Illinois Route 31 Phase I Study:  
Illinois Route 176 to Illinois Route 120  
McHenry County

### Community Advisory Group (CAG) Meeting #5

**Workshop Comments on Preferred Alternative Aerial Exhibit:**

Picture 1

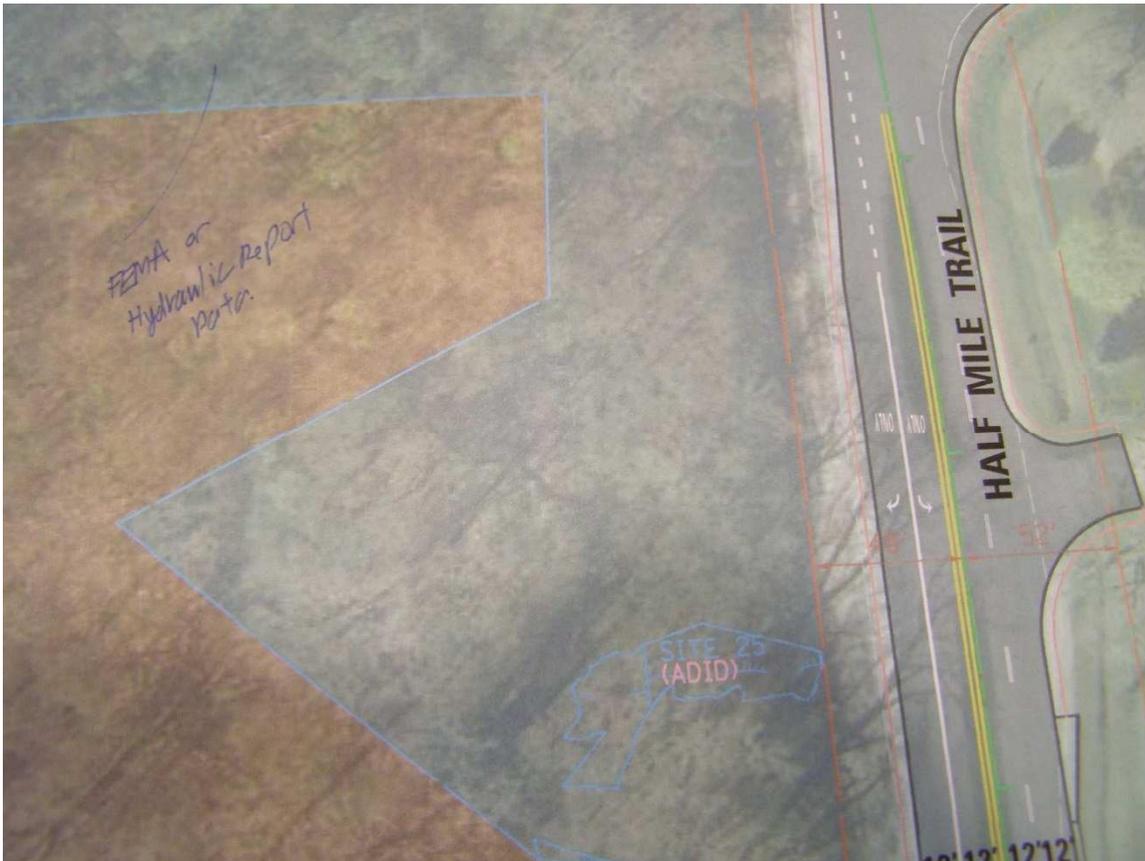
Comment 1: Property name mislabeled. Property on west side of IL 31 should be called out as "TC Industries"

Comment 2: Note to minimize ROW or TE on west side of IL 31 from Sleepy Hollow Creek to the north entrance of TC Industries.

Comment 3: High pressure gas line on west side of IL 31.

**Response: This will be revised for the public hearing exhibits.**

**Response: We will work with TCI on minimizing impacts to the existing landscaping.**

**Response: Noted. Utilities are shown in the Location Drainage Study.**

Picture 3

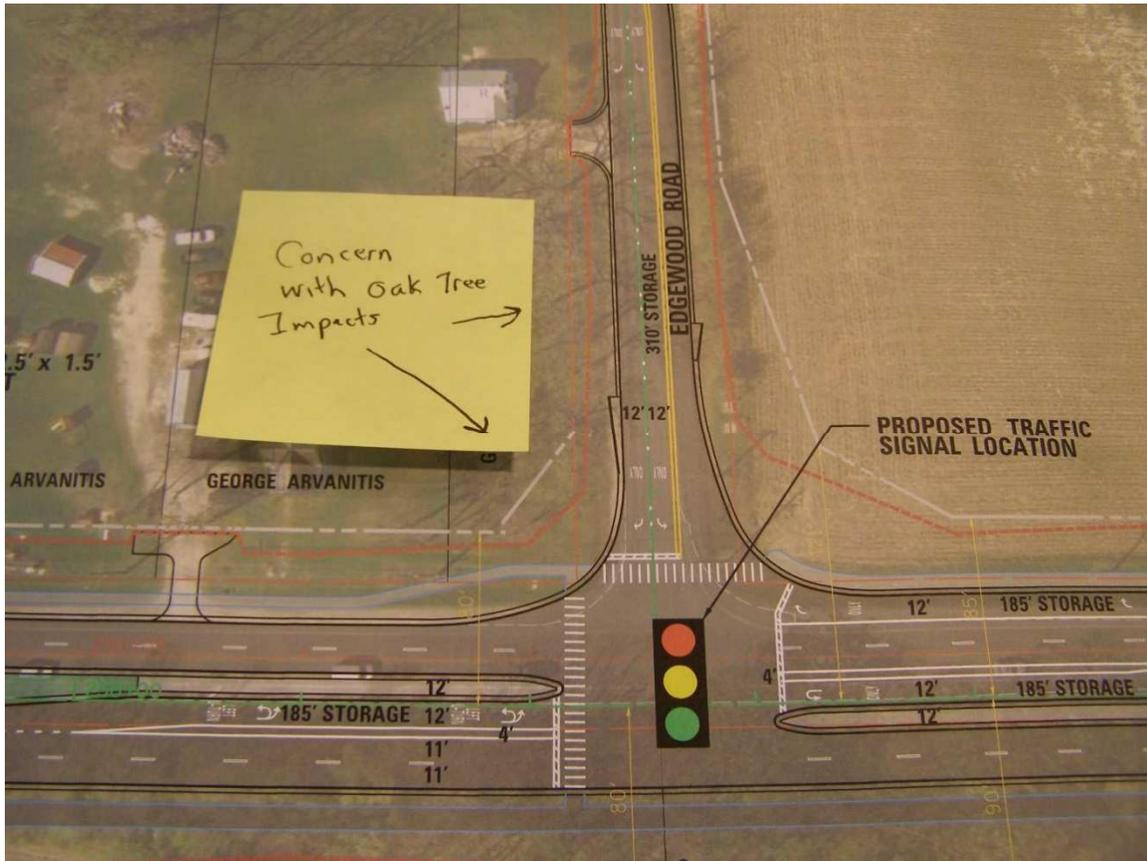
Comment 1: Center new driveway north of TC Industries on property line with vacant parcel on west side of IL 31.

**Response: The median opening and shared entrance will be centered on the property line so both parcels benefit.**

Picture 4

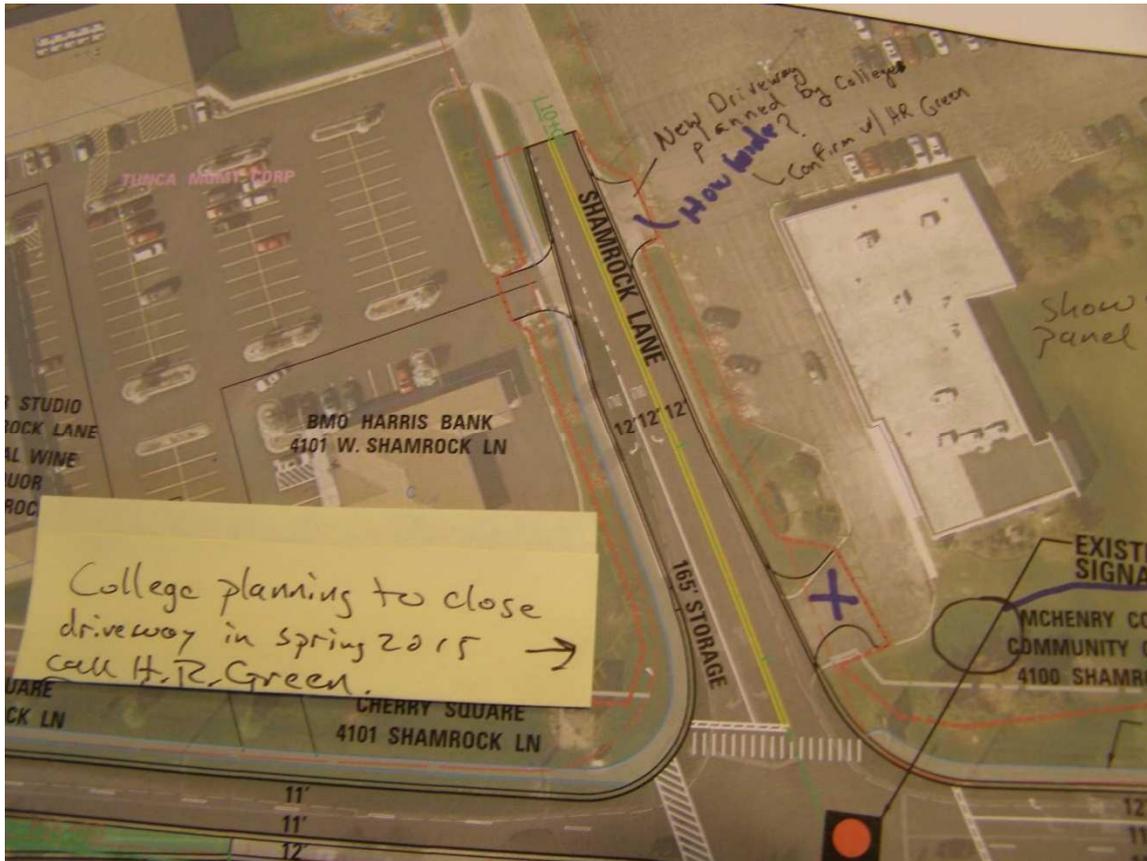
Comment 1: Concern with Oak Tree impacts on SW corner of IL 31 and Edgewood Road, as well as Oak trees on south side of Edgewood Road.

**Response:** This area was field checked with the property owner after the CAG meeting and it was determined that the impacted trees in concern, on the SW corner of the intersection, are not oak trees but they are ash trees. The oak trees along the south side of Edgewood Road outside of the existing right-of-way will be avoided. The two oak trees within the existing right-of-way may be impacted due to required profile adjustments and ditch grading along Edgewood Road. Efforts to avoid impacts to these trees are currently being investigated. Further coordination with the adjacent property owner will be conducted. If the oak trees are impacted, new trees will be planted according to the IDOT tree policy and the removed trees will be recycled / reused in coordination with the Village of Prairie Grove.

Picture 5

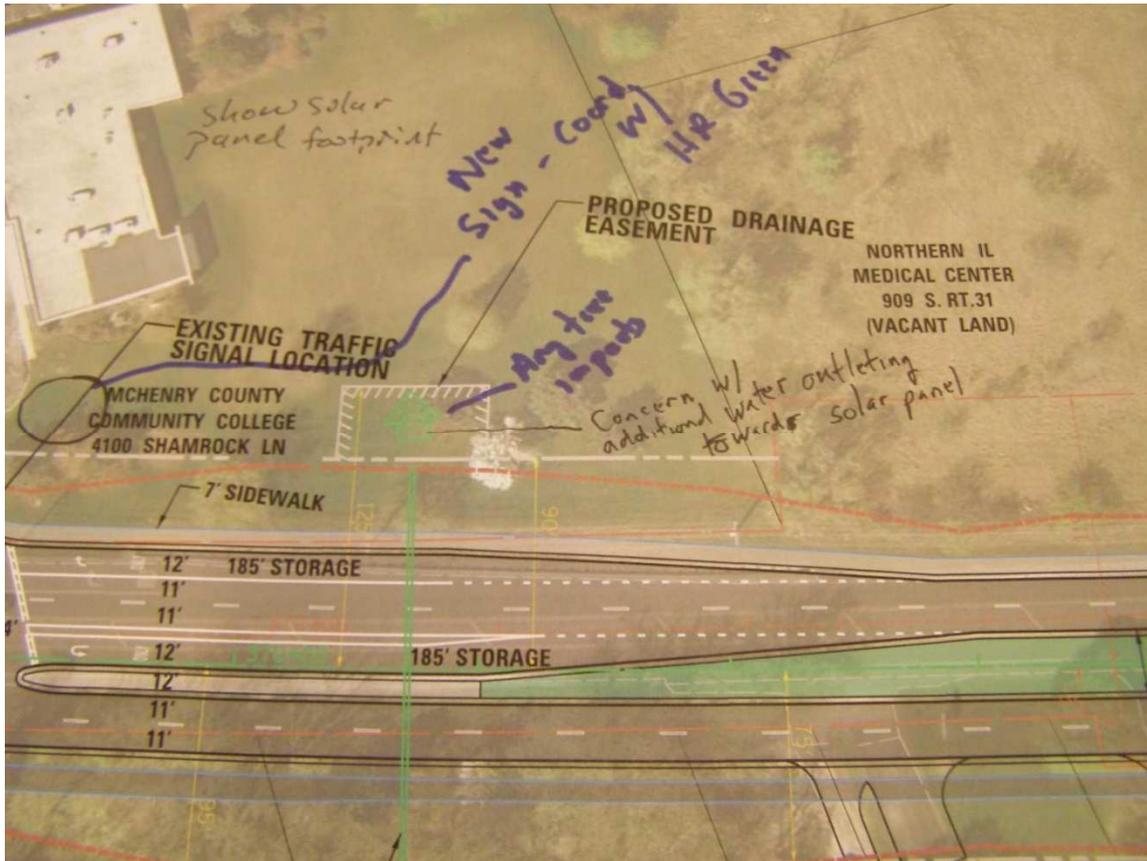
Comment 1: McHenry County College planning to close 1<sup>st</sup> (eastern) driveway entrance to Shah Center in Spring 2015. Design team should contact HR Green for proposed design plans.

Comment 2: McHenry County College planning to reconstruct 2<sup>nd</sup> (western) driveway entrance to Shah Center in Spring 2015. Design team should contact HR Green for proposed design plans.

**Response:** The plans will be revised to reflect this.

**Response:** The plans will be revised to reflect this, once information is received from HR Green.

Picture 6

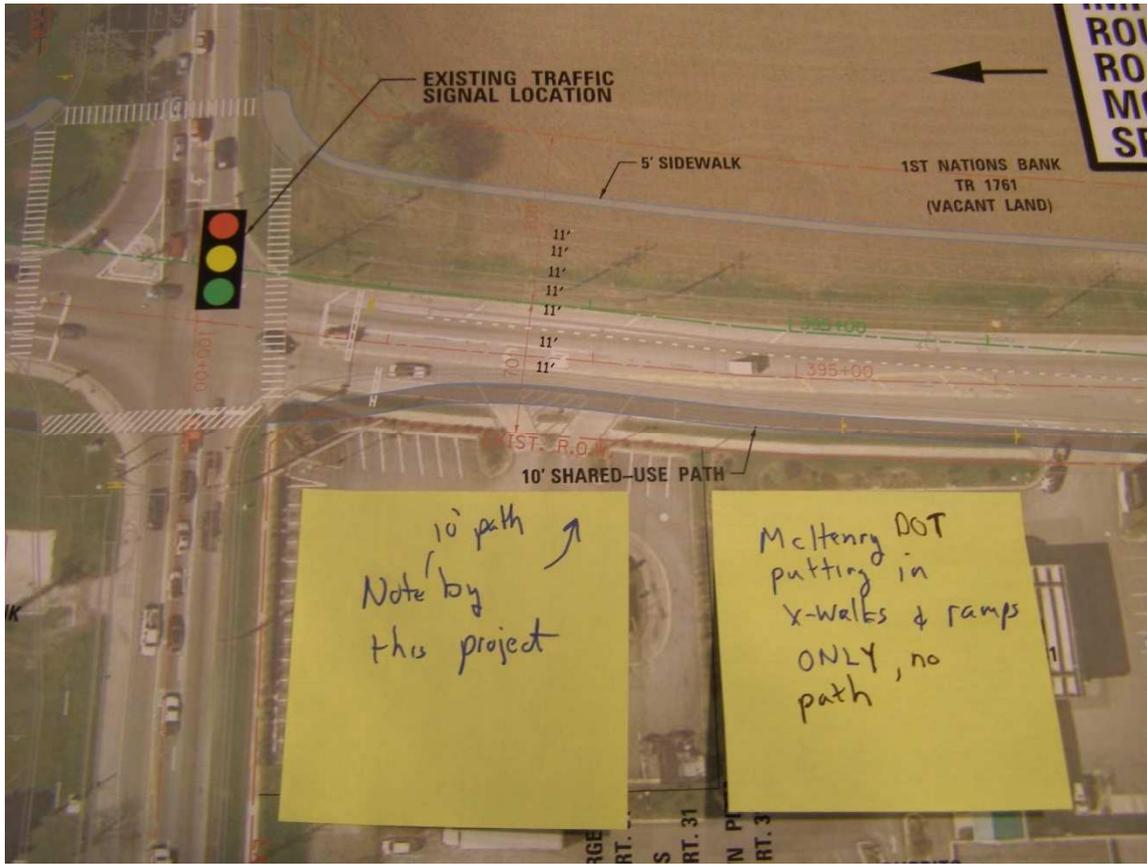
Comment 1: McHenry County College planning to construct new sign for Shah Center in Spring 2015. Design team should contact HR Green for proposed design plans and provide them with limits of improvement / proposed ROW requirements for IL 31 project.

Comment 2: McHenry County College has recently constructed new solar panels for the Shah Center building. Show approximate footprint and label on plan.

Comment 3: Concerned with tree impacts due to culvert outfall re-grading at outlet 20, as well as additional water outletting towards solar panels.

**Response: Coordination will be completed with HR Green regarding the new sign location.**

**Response: IL 31 proposed improvements will not impact the solar panels. Approximate footprint will be shown and a note will be added to aerial exhibit for public hearing indicating "New Solar Panels (by others)."**

**Response: The proposed improvements will impact two trees within the Shah Center proposed right-of-way; there are no trees within the temporary easement area. Both of the impacted trees are silver**

maples in poor health; one is multi-stemmed with 17.5" and 17.0" trunks and the other has a 14.0" trunk. Any impacted trees will be replaced per IDOT tree policy. The proposed improvements will not increase the amount of water outletting to the property and current conditions will be maintained, in accordance with IDOT stormwater management policy.

Picture 7

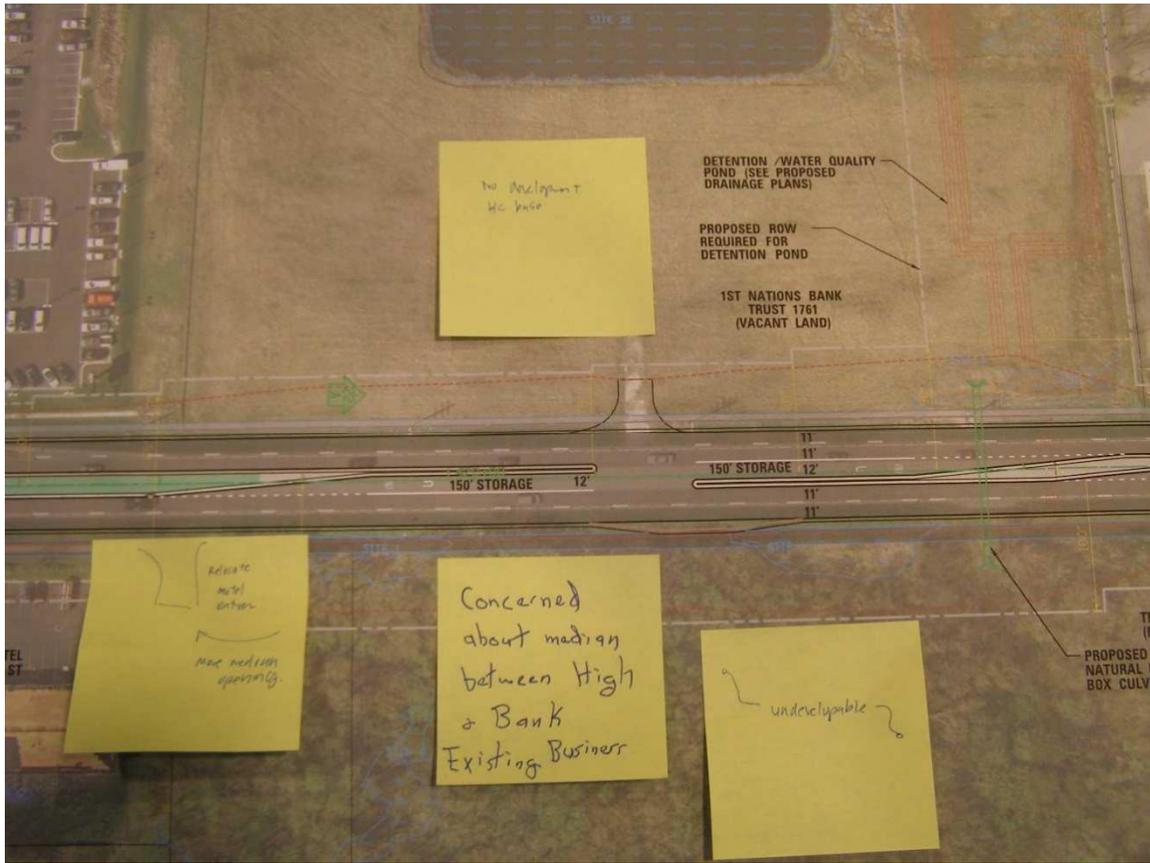
Comment 1: Add note on exhibit that 10' wide path is part of this project. McHenry County DOT is not putting in path or sidewalk as part of their Bull Valley Road improvement project, only x-walks and ramps at the intersection.

**Response: The exhibits and plans will be revised.**

Picture 8

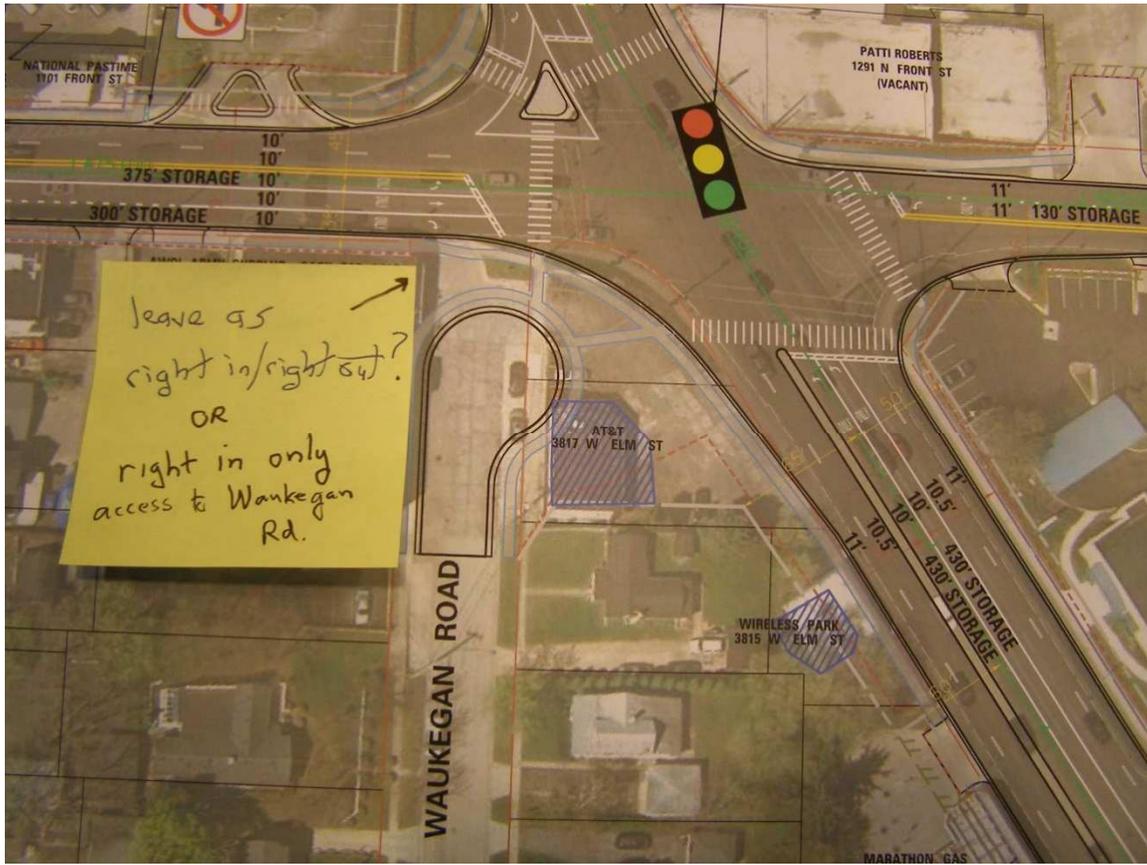
Comment 1: CAG member noted that no development is currently planned for empty parcel on west side of IL 31, north of Buss Ford.

Comment 2: Concerned about proposed barrier median between High Street and Bank Drive restricting access to existing businesses.

Comment 3: Suggestion to relocate entrance to motel and move median opening to new entrance location. New entrance should be along property line between motel and vacant parcel to the north.

Comment 4: CAG member noted that empty parcel on east side of IL 31 is undevelopable.

**Response: Noted.**

**Response: A key element of the project is to improve safety. The amount of undeveloped land adjacent to IL Route 31 and limited number of side streets and driveways between Park Place and High Street provides an opportunity to utilize countermeasures that have shown great effectiveness in improving safety. A barrier median improves safety by implementing access management measures that reduce the potential for head-on and other types of vehicle crashes. For this reason, a barrier median is also proposed from south of Park Place to IL Route 176. Bi-directional access to the residences and businesses along this section of IL Route 31 will be maintained via the use of median openings with combined left / u-turn lanes at Park Place and High Street. Vehicles wishing to enter or exit a property can do so by performing a u-turn at the closest median opening.**

**Response: This will be discussed further with the City of McHenry. The spacing of median opening at this location would be approximately 900 feet, which is less than the ¼ mile spacing recommended for Strategic Regional Arterials (SRA) routes.**

**Response: Noted.**
